11.07.2012  
**DESIGN REVIEW**  
**REVISIONS**  
DPD Project Number: 3012437

12 AVE ARTS

**We are returning to apprise the board of further elevational development, and to present solutions to the conditions identified at the initial Design Review meeting.**

5

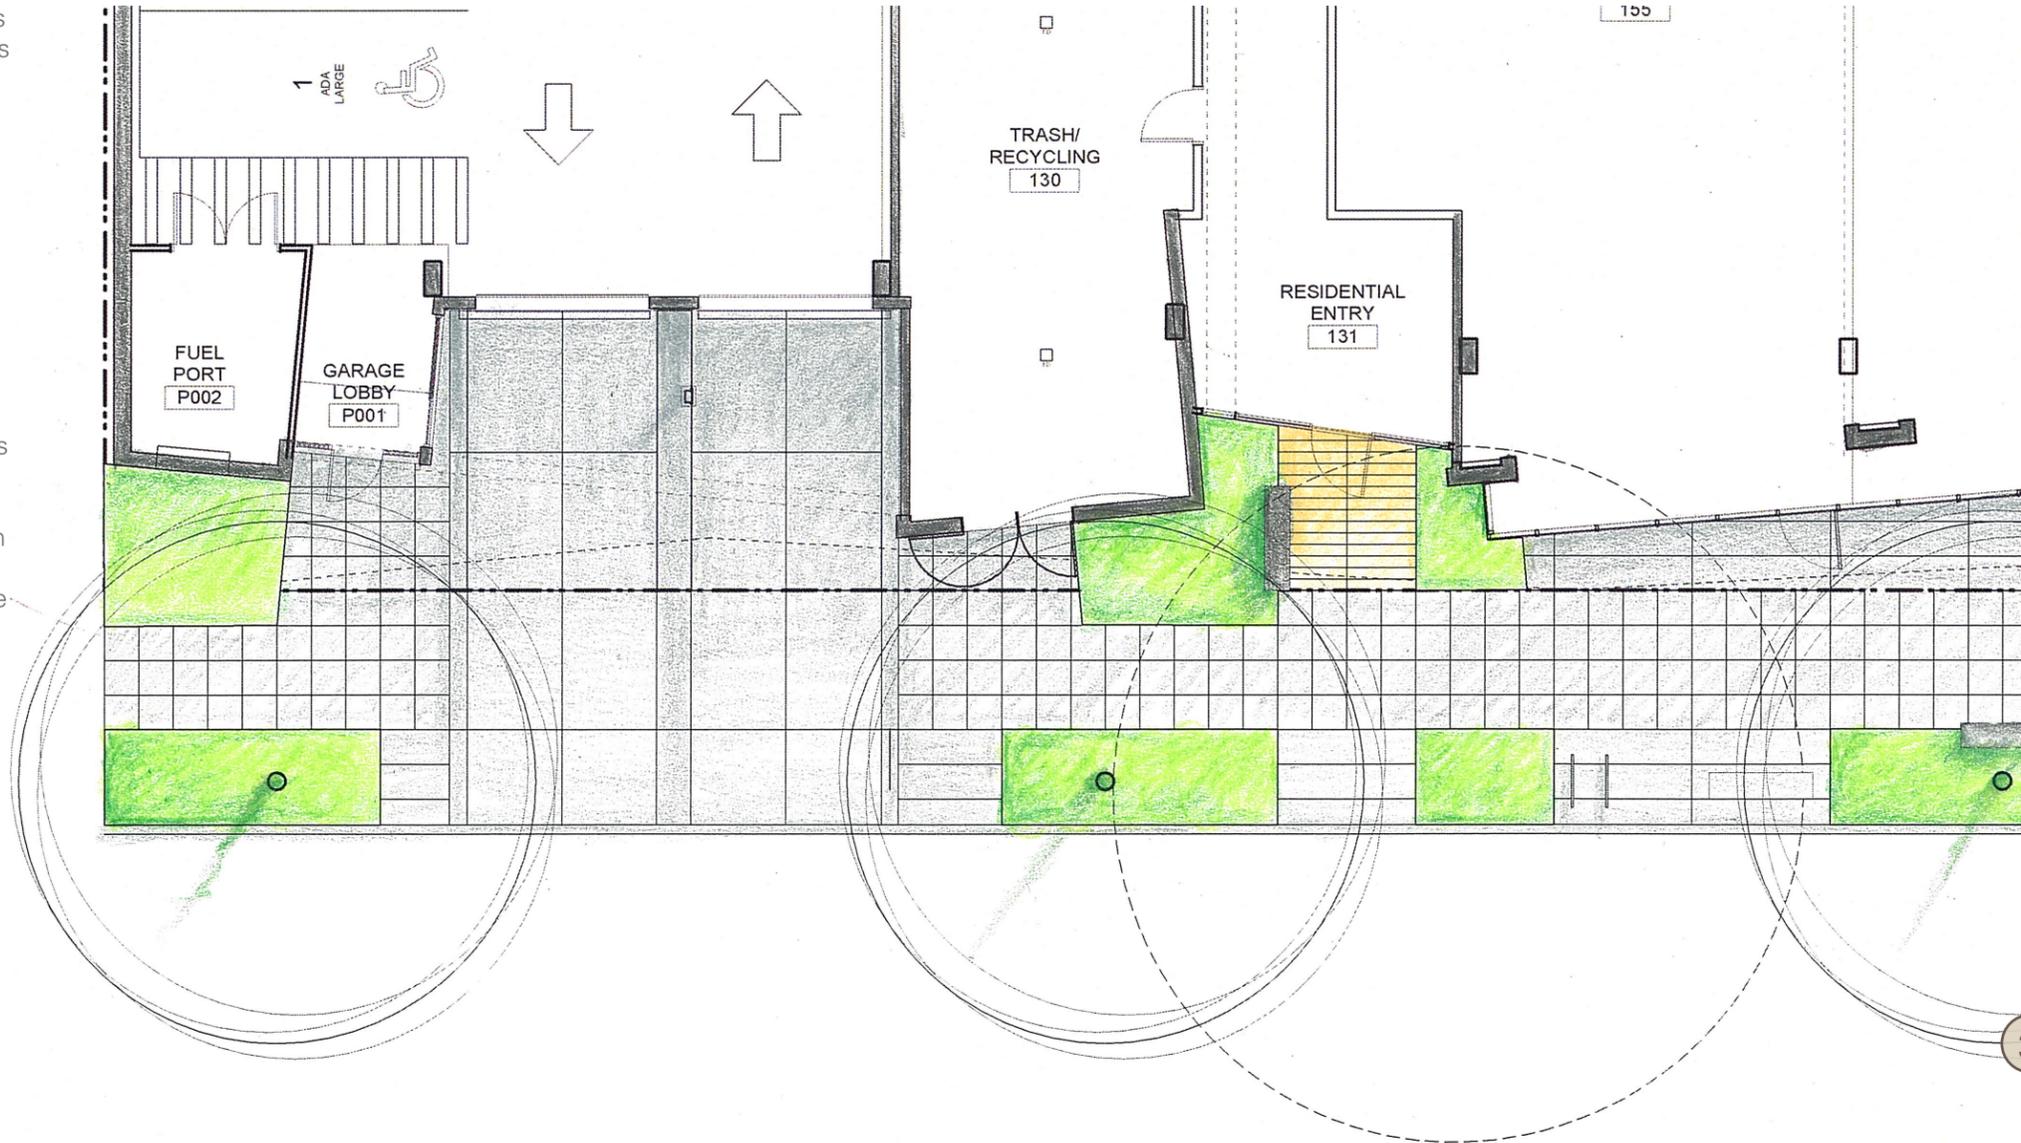
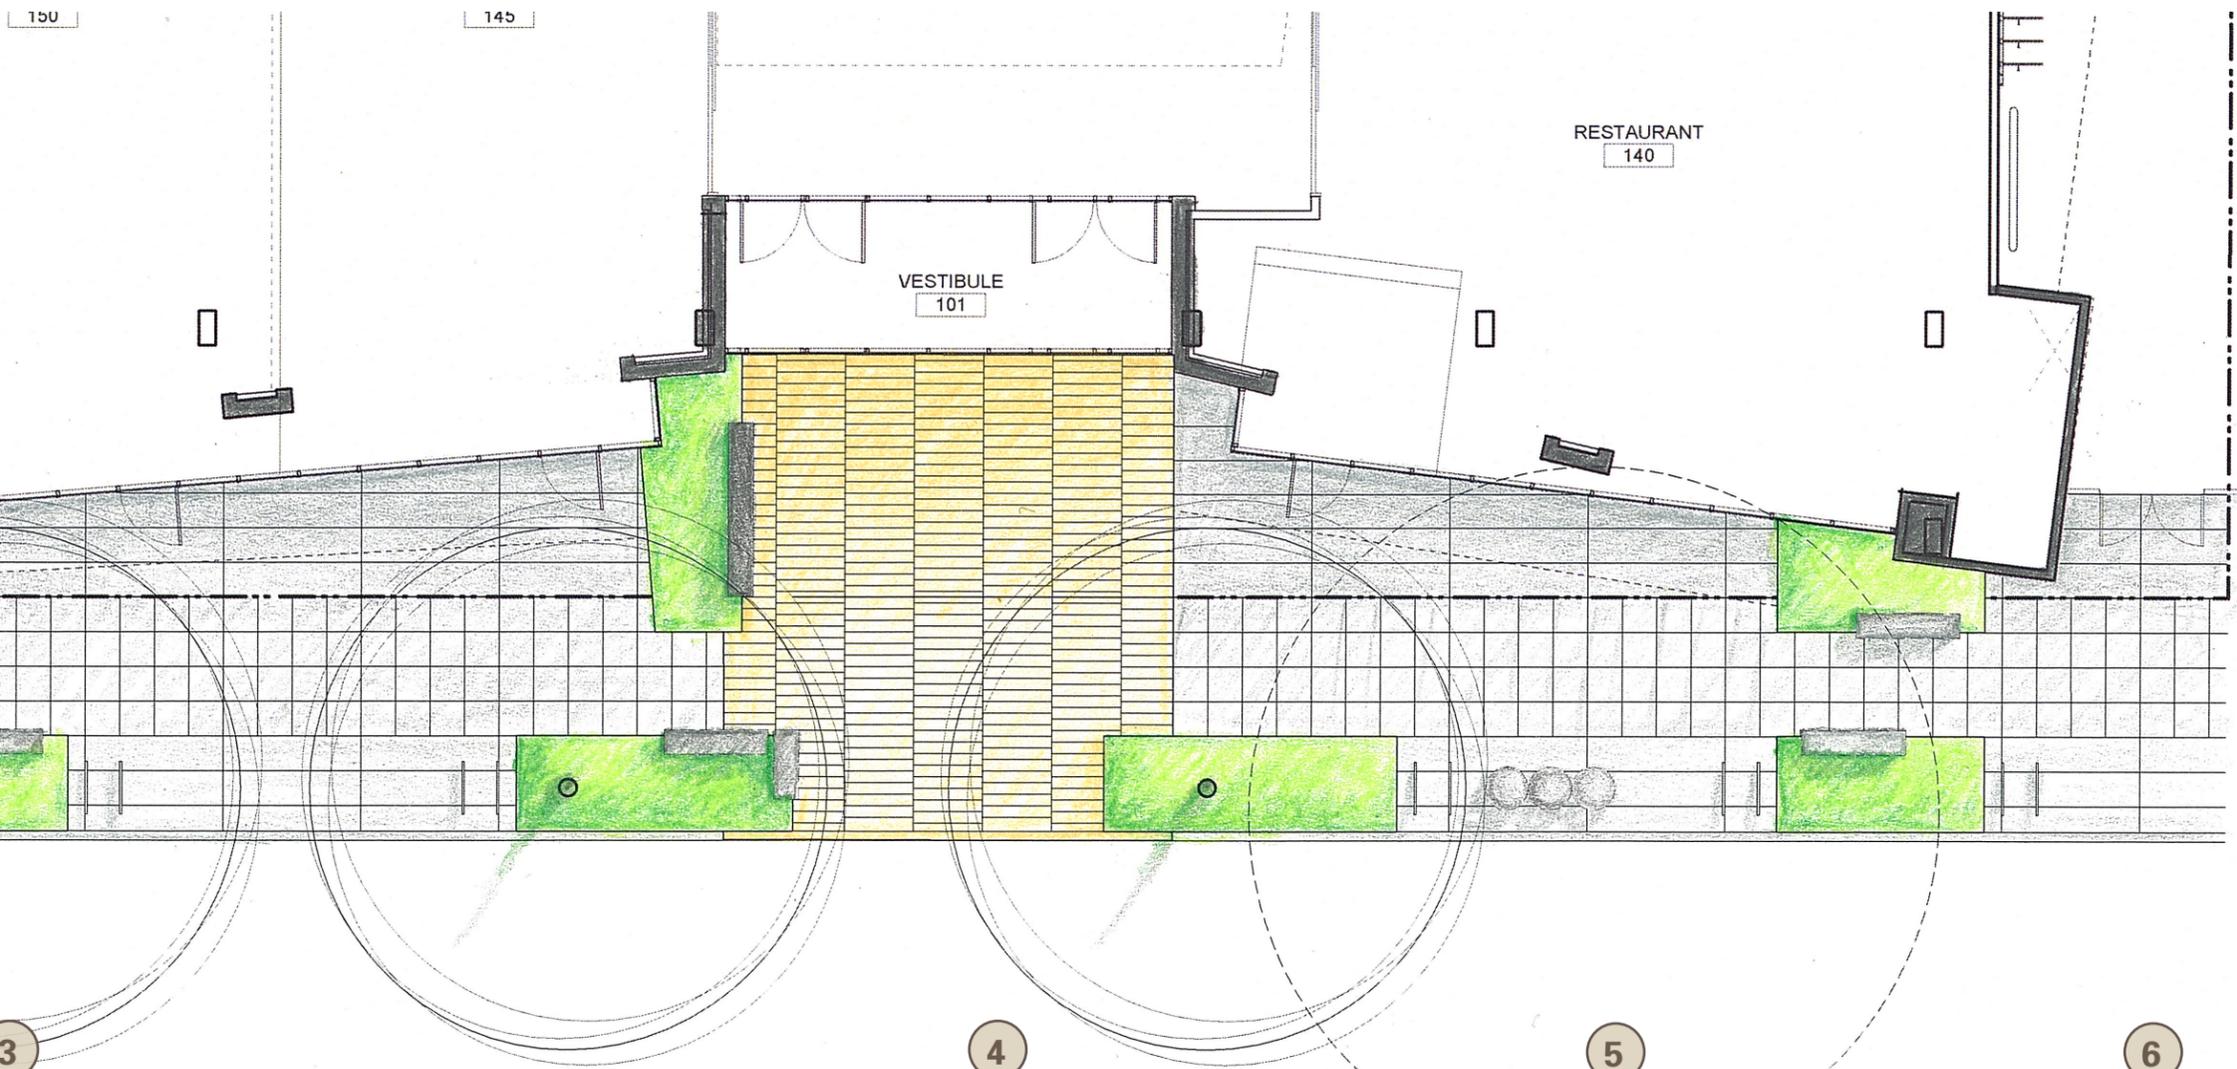
The architectural concept of the building should be carried through the ground level landscape planting scheme and hardscape design more vigorously to establish a clear relationship between the building and the ground level open space.

The building reflects the many functions behind the facade. The cladding also has a distinct patterning of panels and tiles exhibited in its form. The streetscape draws from changes in use and unification in pattern. In the streetscape we play with the transitions between the orthogonal grid of the street and the angles of the building — embracing the grid of the street and of the city — allowing it to interface with the buildings unique characteristics. Sidewalk paving begins with the standard 2x2 city grid and dissolves it into a 2x8 grid as it connects with the building and at the planting strip, while maintaining the street orientation. This 2x8 grid is in proportion with portions of the residential siding system and the concrete patterns of the theater spaces. The grid of the street collides with the angles of the building, distinguishing the building as the distinct element and point of interest. At the main entry points the texture changes to a smaller scale to announce their change in use, while retail spaces are of the street and reflect that pattern

Within that narrative, six distinct zones and transitions have been made.
